City of Portland, Maine - Building or Use Permit Application 389 Congress Street, 04101, Tel: (207) 874-8703, FAX: 874-8716

PERMIT ISSUED
 WITH REQUIREMENTS

DATE: 9 July 98 ADDRESS: 627 Congress ST. (Ø46-D-Ø28)
REASON FOR PERMIT: Temporary Stage Platform
BUILDING OWNER: EXEC. Mgmt Corp - MAINE FILMS INC.
CONTRACTOR: Michael Whittaker
PERMIT APPLICANT: David S.
USE GROUP A-3 BOCA 1996 CONSTRUCTION TYPE 3-B

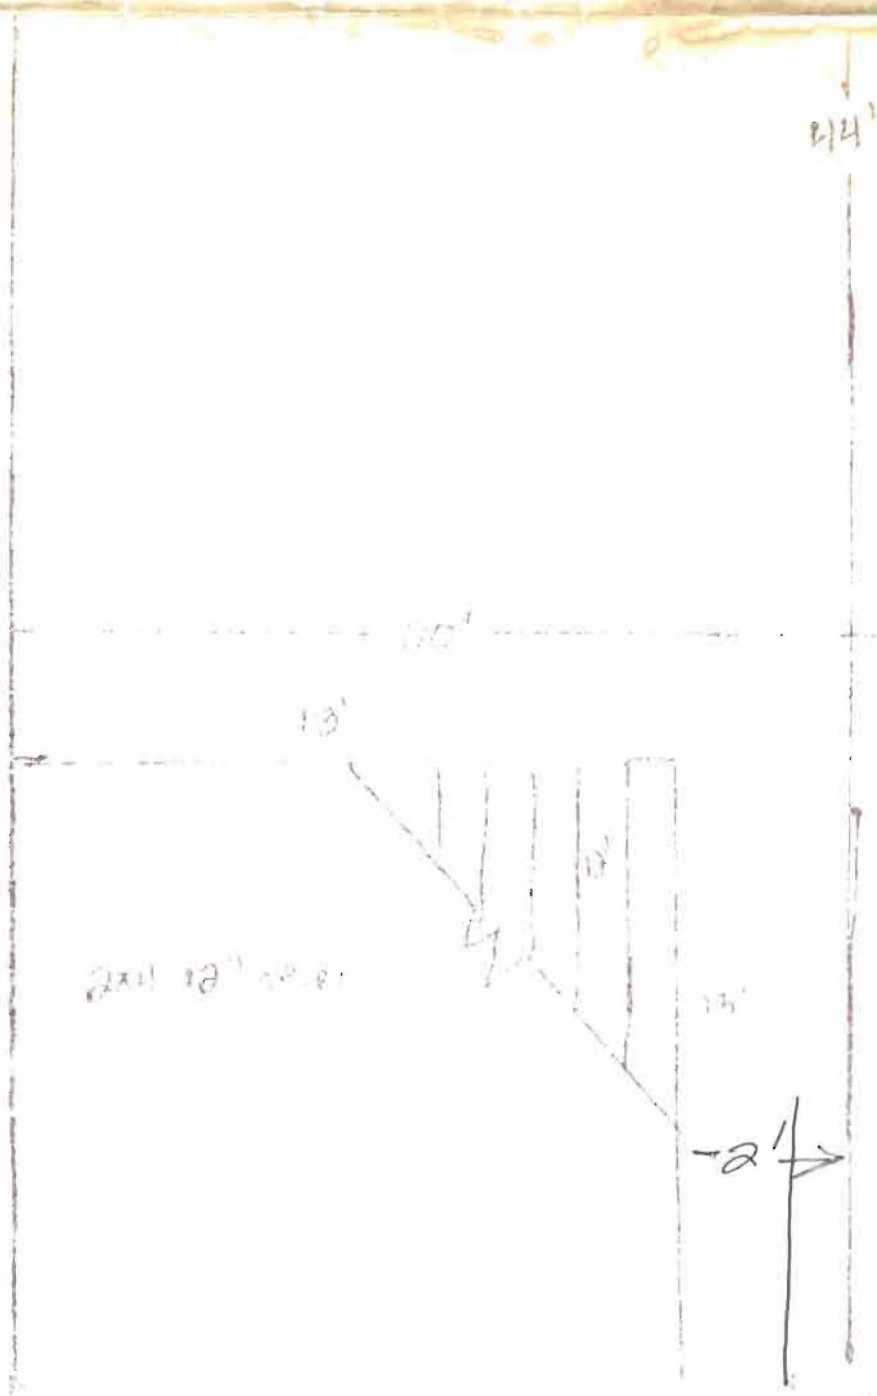
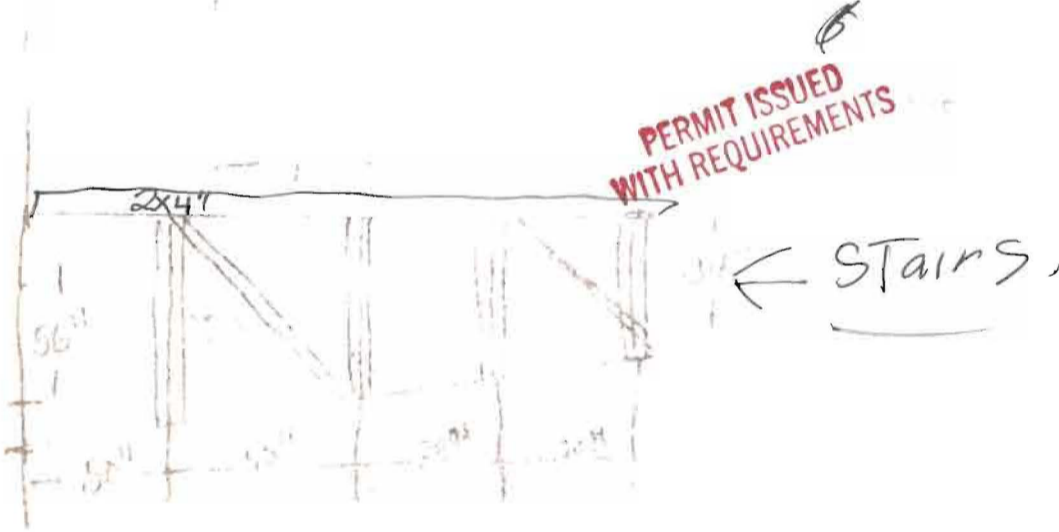
As per Tele. Conv. on 9 July 98
 @ 12:15 stairs to stage
 Temporary one wide set,
 2x4 spanning 50" 50" 28" 28"
 with plywood deck 1/4" 1/2"
 2' From platform to exit door

X 29. Platforms shall be constructed in accordance with section 412.4 of the City's building Code -

X 30. As per telephone conversation on 9 July 1998 The platform will be as per plan and my notes - Temp. one day only 11 July 1998 only
(3) Three Artists on platform at one time.

Approved with the following conditions: *1, *29, *30
